Project
Ferns Farm
Tottington

Project No.
NA-2510

Drawing Title
Rear (North) Elevation
as Proposed_Mark Up

NA (-4) 021

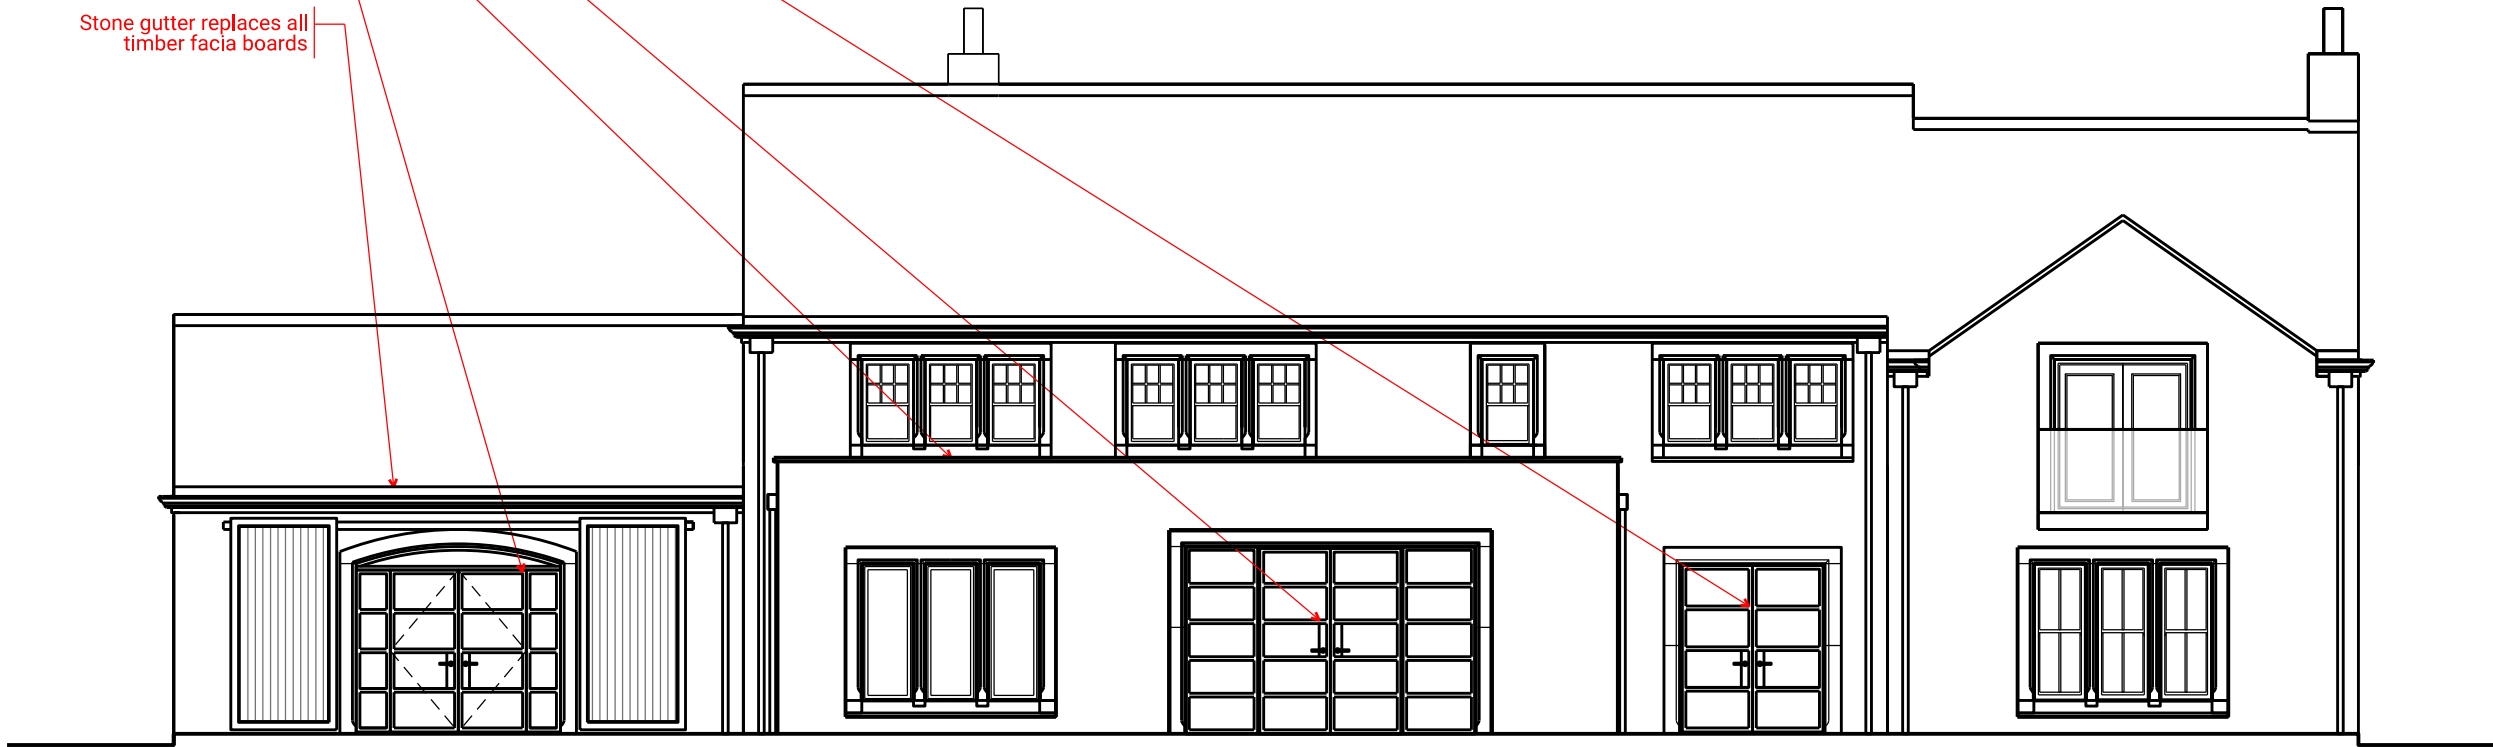
- Single door to become double french aluminium patio door
- Sliding door to change to french aluminium patio doors
- Glass lanterns have been replaced by flat roof light which sit lower than the parapet wall
- Patio doors to chnage to alumium french patio doors with side lights
- Stone gutter replaces all timber fascia boards
